# Super-PON PMD Refinements

IEEE P802.3cs, June 4, 2020  
Liang Du (Google)

# Black link - downstream (informative)

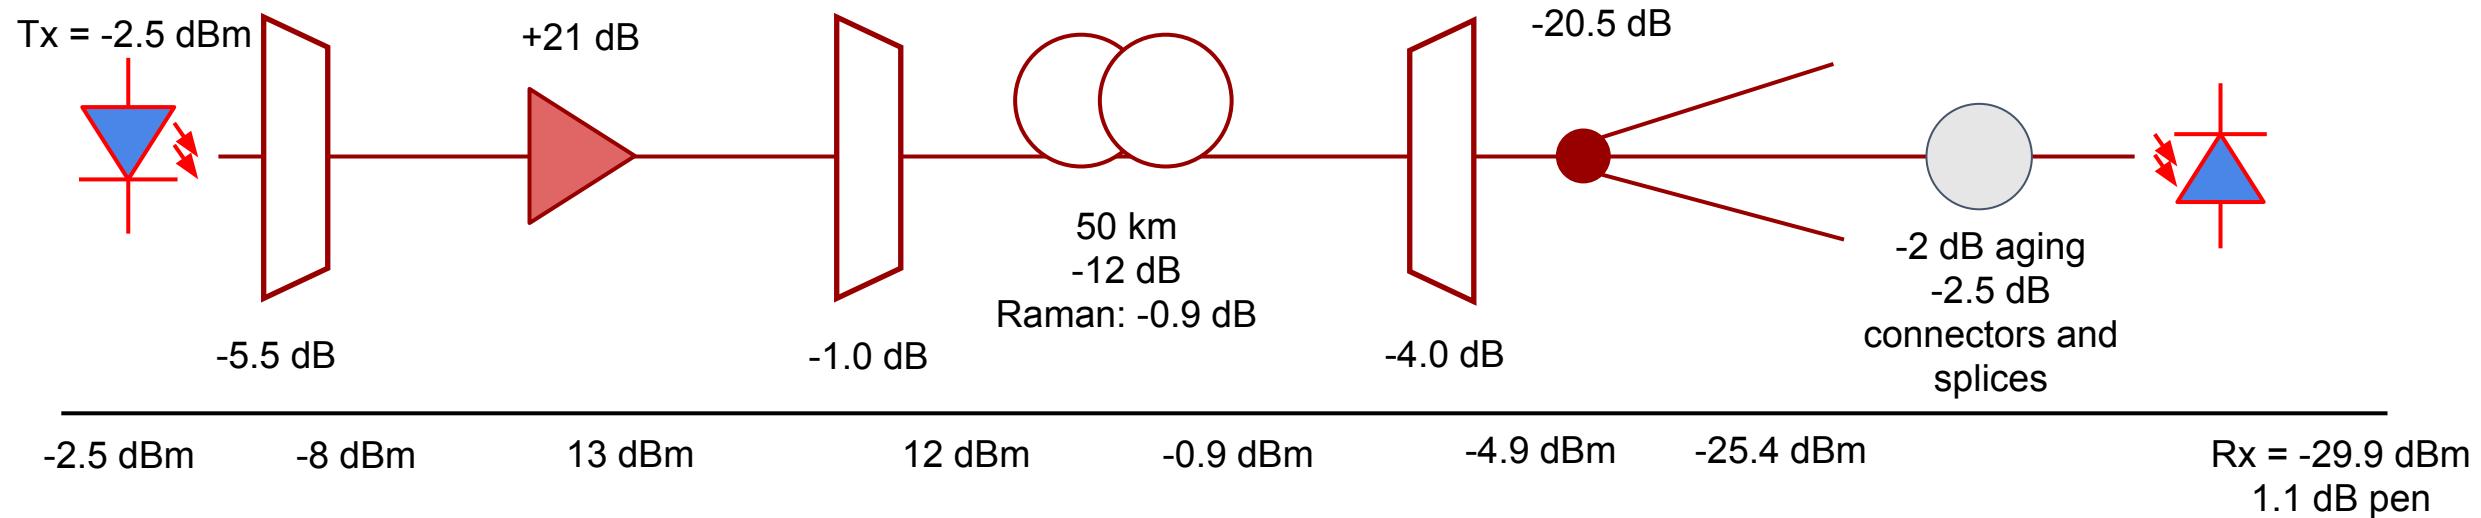
Gain  $\geq 21$  dB

Max power  $\geq 25$  dBm

NF  $\leq 12$  dB

Passband =  $\pm 15$  GHz

inband ripple = 1 dB

loss  $\leq 5.5$  dB

Passband = 1.6 THz

inband ripple = 0.5 dB

loss  $\leq 1.0$  dB

Passband =  $\pm 15$  GHz

inband ripple = 1 dB

loss  $\leq 4.0$  dB

Temp range: -40 to 65 C

# Black link - upstream (informative)

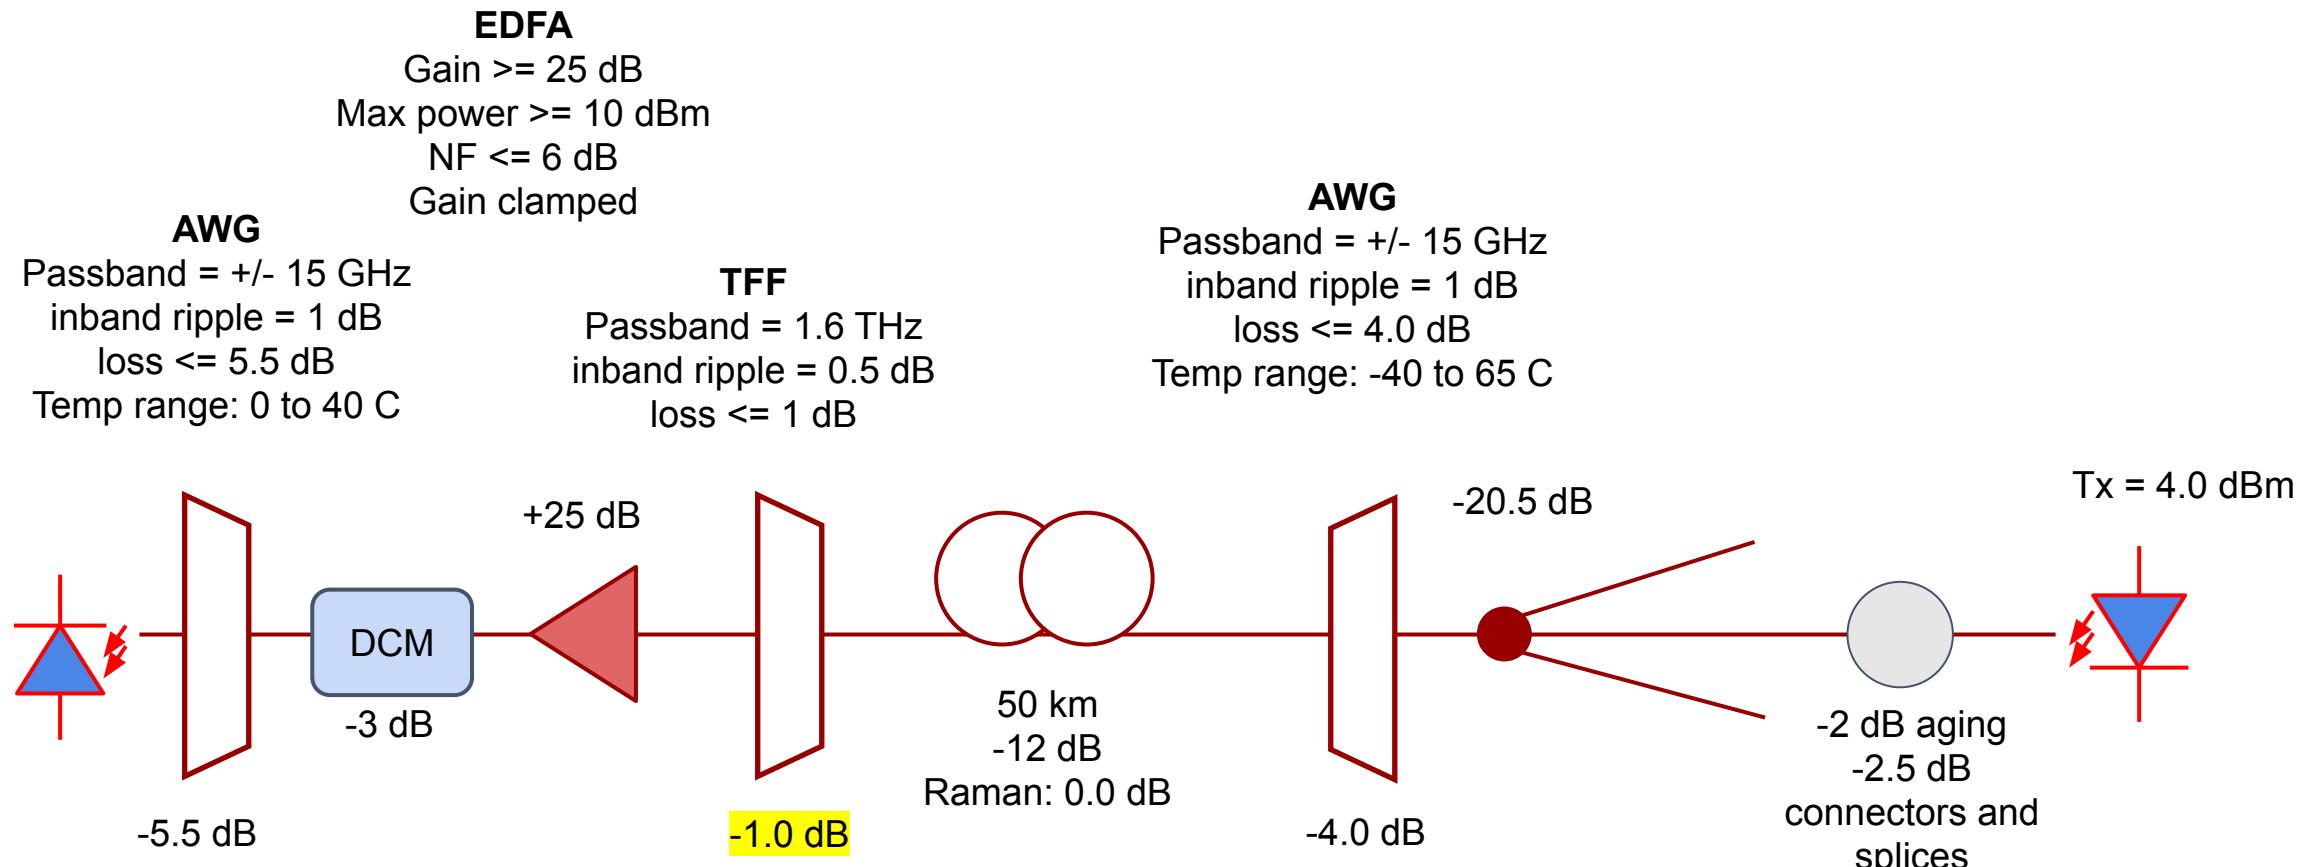
Rx = -21.5 dBm  
OSNR = 14 dB  
2.1 dB pen

-13 dBm  
OSNR = 14 dB
